HISTORIC AND DESIGN REVIEW COMMISSION

HDRC CASE NO: 2022-345
ADDRESS: 305 LAVACA ST
LEGAL DESCRIPTION: NCB 708 BLK 8 LOT 2
ZONING: RM-4, H
CITY COUNCIL DIST.: 1
DISTRICT: Lavaca Historic District
APPLICANT: Caroline Gado
OWNER: Leslie Jones/1918 MLK DEVELOPMENT GROUP LLC
TYPE OF WORK: New construction of two, 2-story duplex structures
APPLICATION RECEIVED: June 13, 2022
60-DAY REVIEW: Not applicable due to City Council Emergency Orders
CASE MANAGER: Rachel Rettaliata

The applicant is requesting conceptual approval to construct two, 2-story duplex structures at 305 Lavaca.

Historic and Design Review Commission
Design Review Committee Report

① FRONT ELEVATION- SOUTH
SCALE: 1/4" = 1'-0"

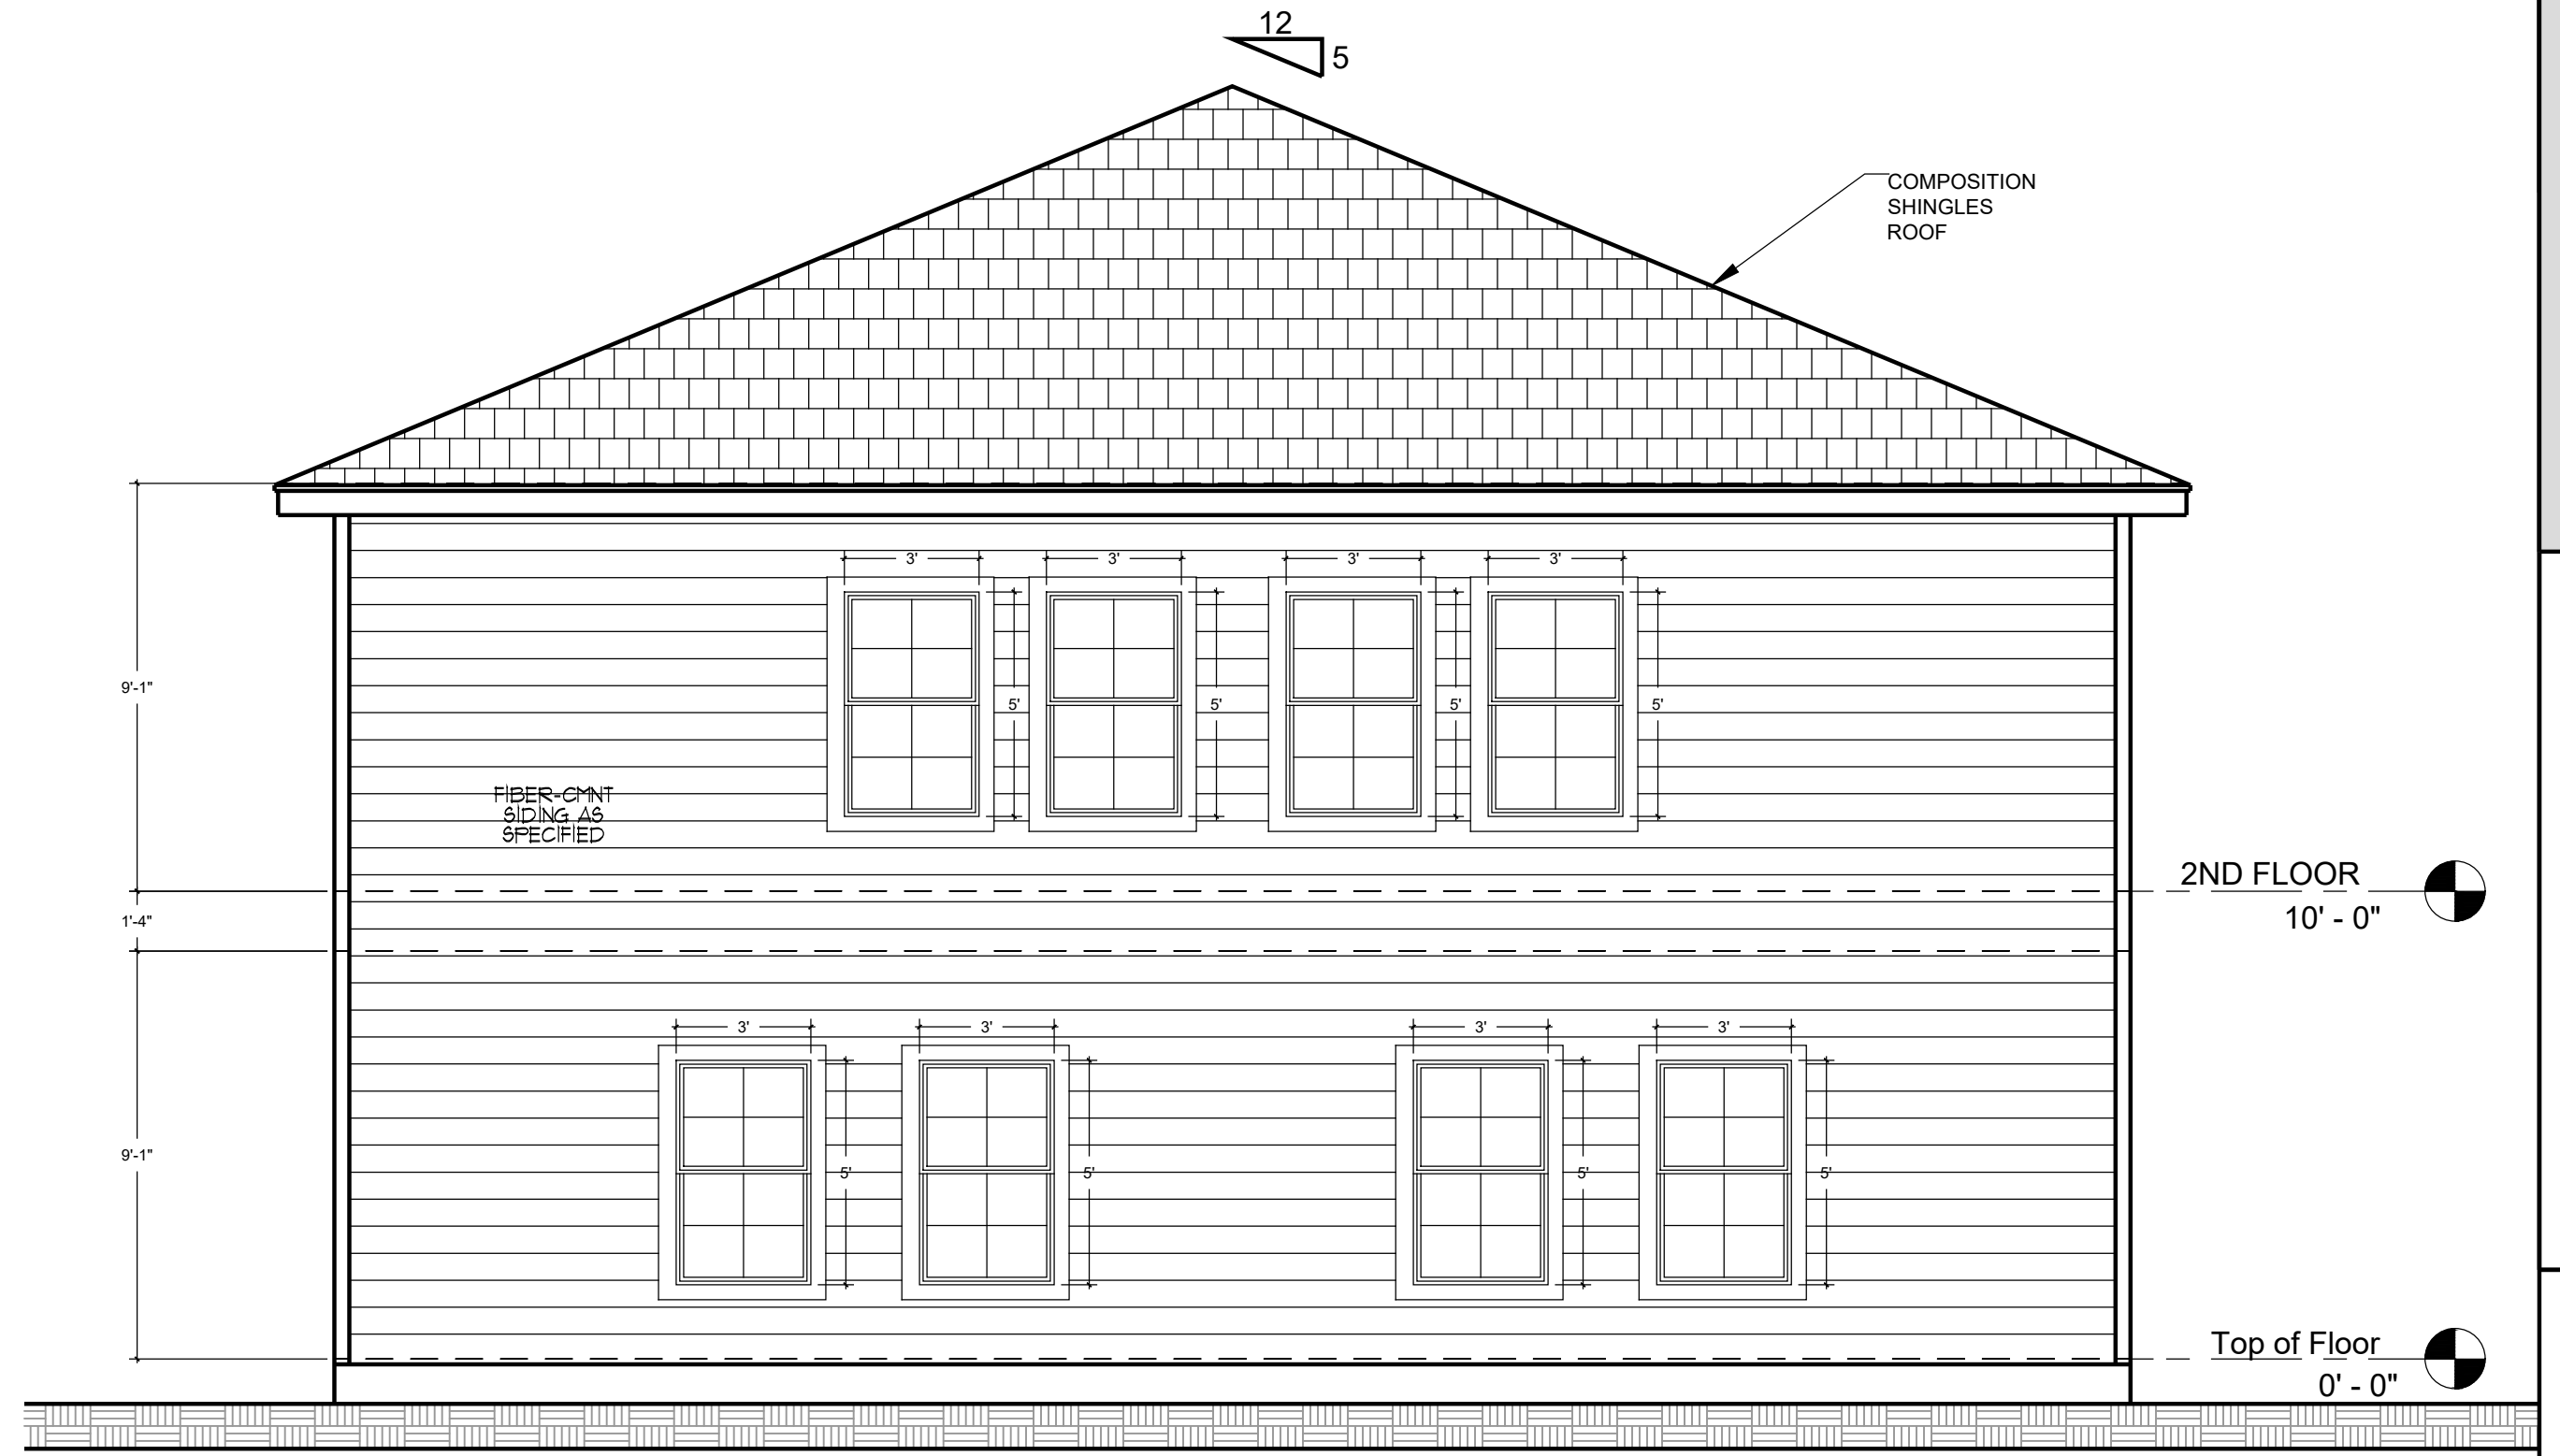
- o. **FRONT PORCH** – The applicant has proposed to construct a double-height front porch on each of the duplex structures. The proposed front porches feature a central wall with cement board siding on a brick-clad base, square posts with brick-clad bases, a second-floor porch handrailing, and decorative gable detailing. Staff finds that the front porch elements should be designed to be in keeping with the historic structures on the block.

LG: As far as massing and window and roof shape, this seems to comply looking at the elevations. There is an unusual window orientation, looking at the rear elevation.

LG: I have a design question related to the front elevation and the brick base on the columns. The brick base is something that you may see on a Craftsman home and the columns are more Neo-Classical in style.

RM: The central wall has a strange appearance.

LG: Having two columns in place of the divider wall may be more in keeping with the predominant style of the neighborhood.

RM: I think the brick would work best as a free-standing column as opposed to a column on a brick base.

- v. That the applicant incorporates front porch elements that are in keeping with the historic structures on the block based on finding o.
- vi. That the applicant submits material specifications for the permeable surfacing to staff for review and approval prior to returning to the HDRC for final approval based on finding p.

3 SITE PLAN
SCALE: 1"=100'

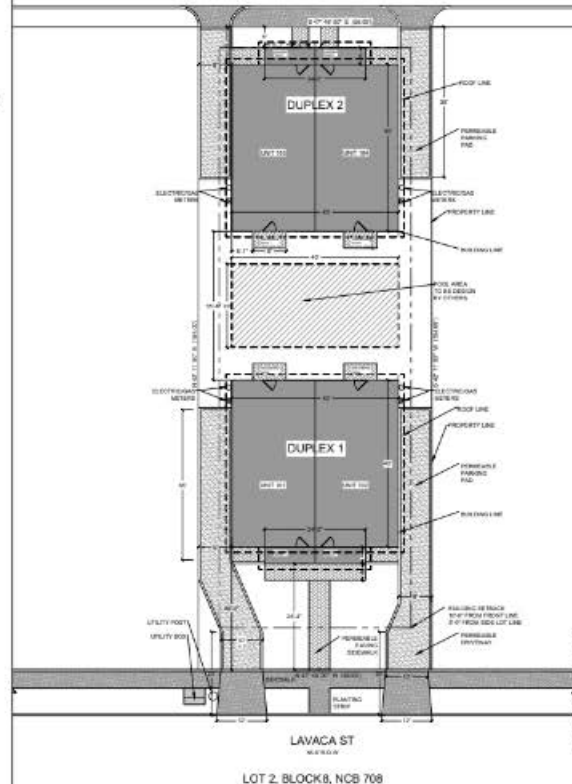
LG: Can you discuss the site plan a bit further? Will there not be parking or a thru-drive.

RM: It looks like there is not enough room for 2 driveways.

Late Submission
Not included in staff's review
GARFIELD ALLEY
H.W. 100'
